Slave Startup : Duration Of SILENT State And Defining timing_lock_OK

Seid Alireza Razavi Majomard, Ehab Tahir , and Ragnar Jonsson

June 7, 2022

Figure 165–28—PHY Control state diagram

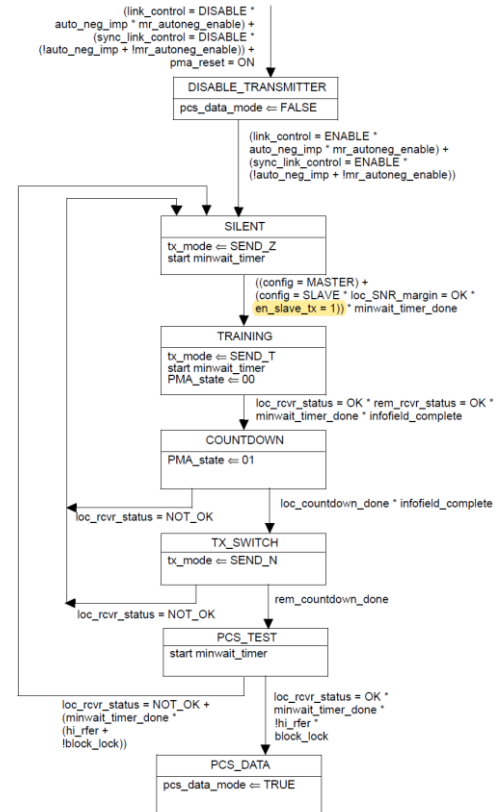
- Slave has to detect the infofield
 - “During startup, prior to entering the TRAINING state, the **SLAVE shall** align its transmit 65B RS-FEC frame to within +0/−4 partial PHY frames of the MASTER as seen at the SLAVE MDI. The SLAVE Infofield partial PHY frame count shall match the MASTER Infofield partial PHY frame count for the aligned frame”
 - Slave shall detect `en_slave_tx = 1` in master infofield (PHY Control state diagram)
- The main task is making sure slave transmission does not cause problem for Master
